# Super-PON timing

Liang Du (Amazon)

# Different timing allowances

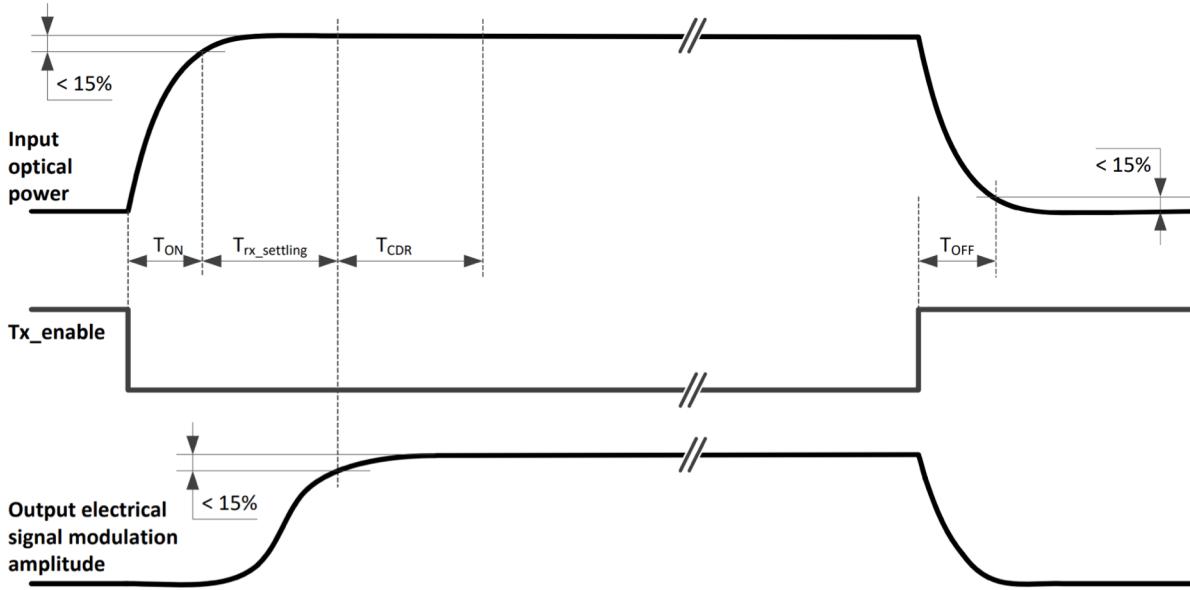
<b>802.3av</b>	<b>802.3ca</b>	<b>802.3cs</b>
$T_{ON}$	512ns	128ns	<b>256ns</b>
$T_{Rx}$	800ns	800ns	<b>800ns</b>
$T_{CDR}$	400ns	400ns	<b>400ns</b>
$T_{OFF}$	512ns	128ns	<b>128ns</b>

- Length of sequences is typically a programmable field in implementation, standards define the worst case that is still considered standard compliant
- EDFA time constants are much longer. No need to consider amplifier transients in timing

- Modify the value of the turn-on time parameter in table 200-7 to be 256 ns
- Modify the value of the turn-off time parameter in table 200-7 to be 128 ns
- Insert the bottom 2 lines of the table on slide 4 into table 200-10  
(with highlights removed)
